PRE-BID MEETING SUMMARY
CARVEL STATE OFFICE BUILDING
EMERGENCY HEAT PUMP REPLACEMENT
OMB/DFM # MC1002000280
ADDENDUM #1

F. Addendum #1

MECHANICAL – 6TH FLOOR PLAN
 M-104 SCALE: 1/8"=1'-0"

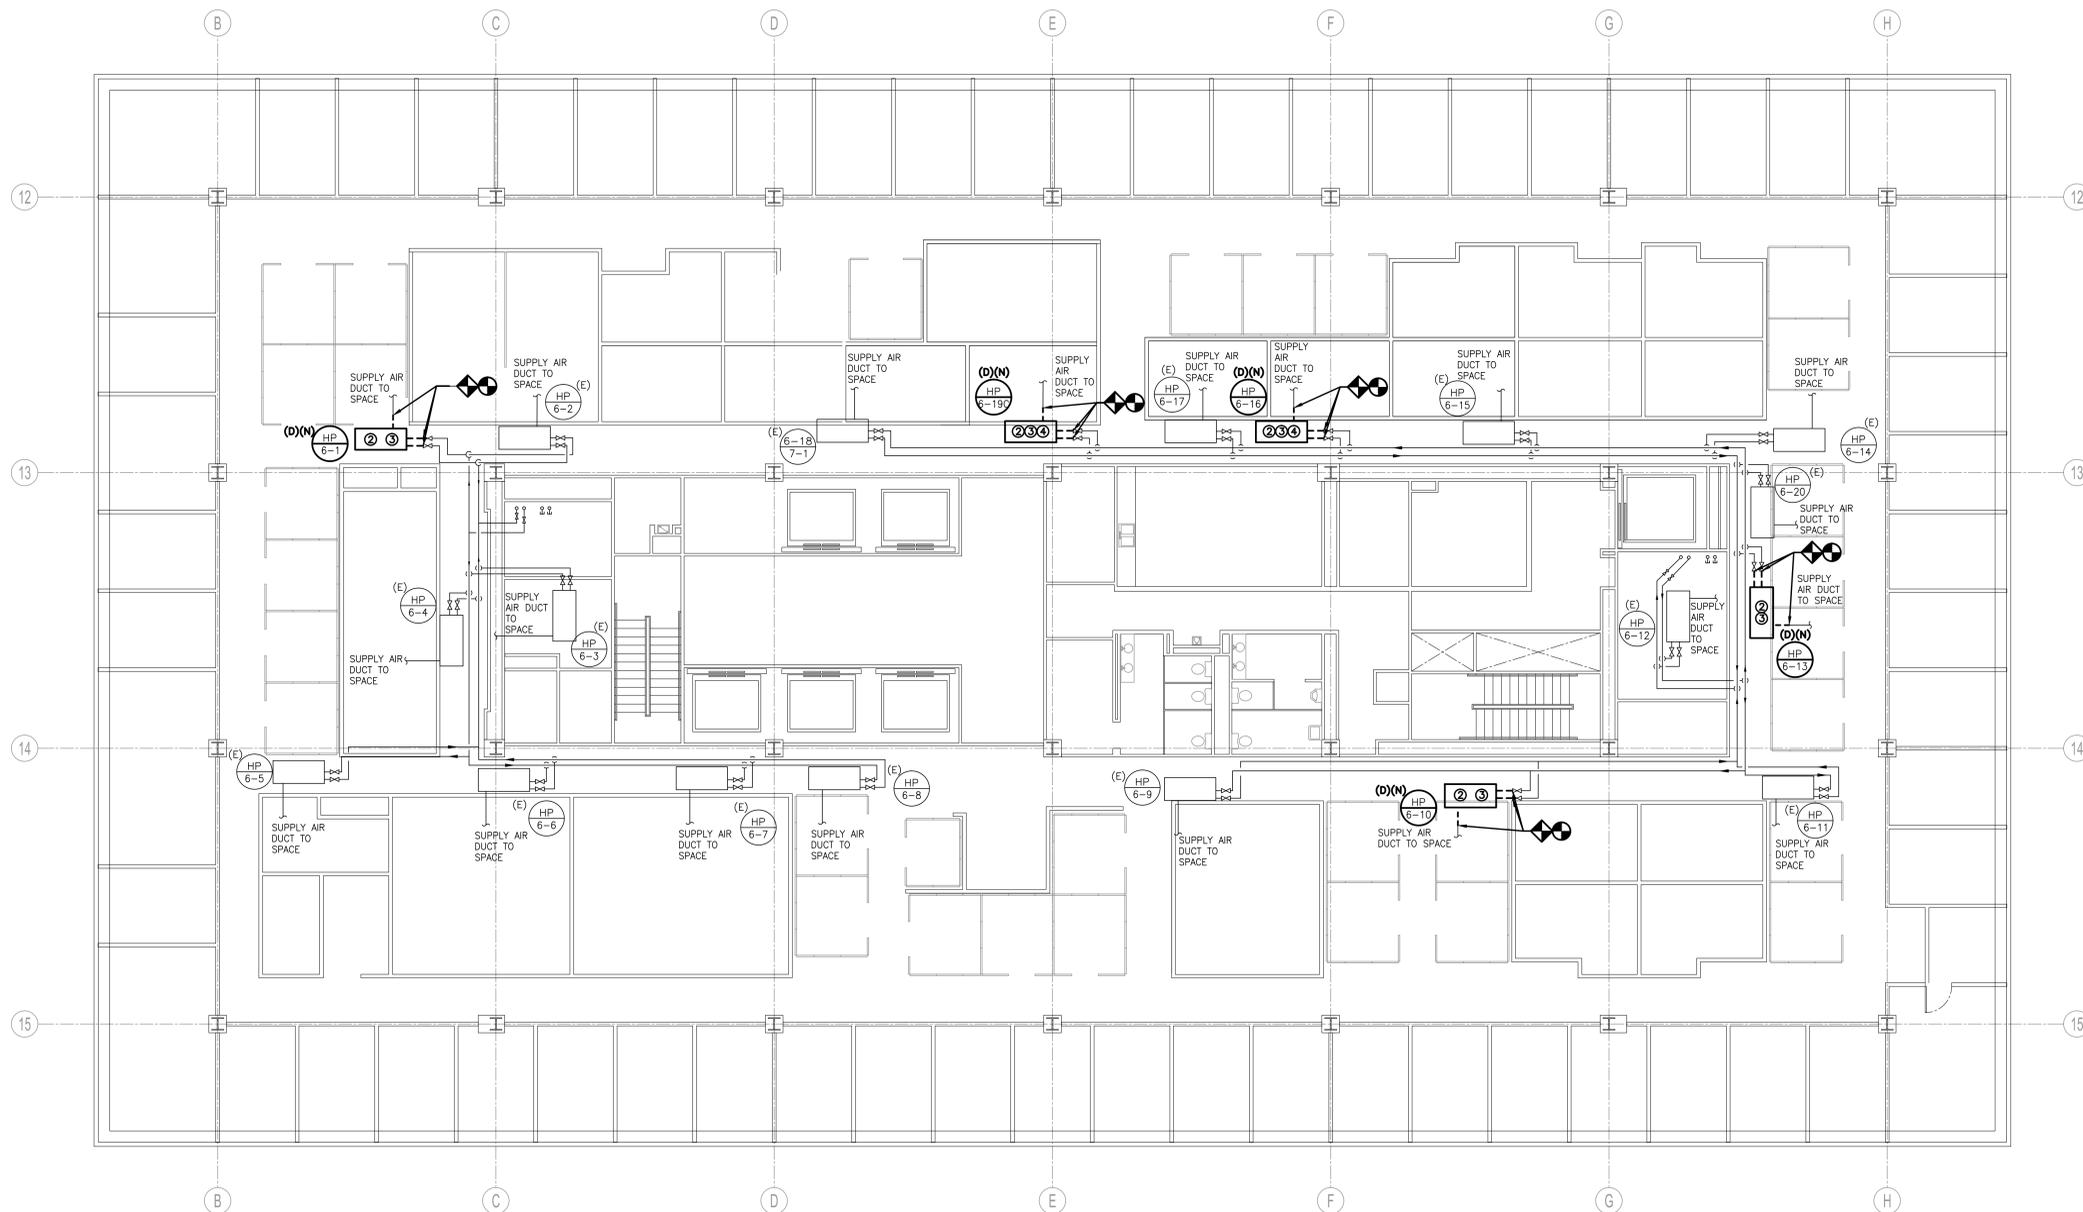
1. Drawing Note 2 on drawings M-101 thru M-104 states the following: Replace existing water source heat pump and associated hangers, supports, drain pans and appurtenances. Contractor shall reuse existing BAS controller on new water source heat pump. Provide all necessary duct transitions. Contractor shall be responsible for disconnecting and removing lighting, fire alarm devices, speakers, ceiling tiles, and grid as required to replace the existing water source heat pump.

This note shall be revised to say the following: Replace existing water source heat pump and associated hangers, supports, drain pans and appurtenances. Contractor may reuse existing BAS controller, if compatible with new heat pump. Contractor shall provide a new heat pump controller if the existing controller is not compatible. Provide all necessary duct transitions. Contractor shall be responsible for disconnecting and removing lighting, fire alarm devices, speakers, ceiling tiles, and grid as required to replace the existing water source heat pump.
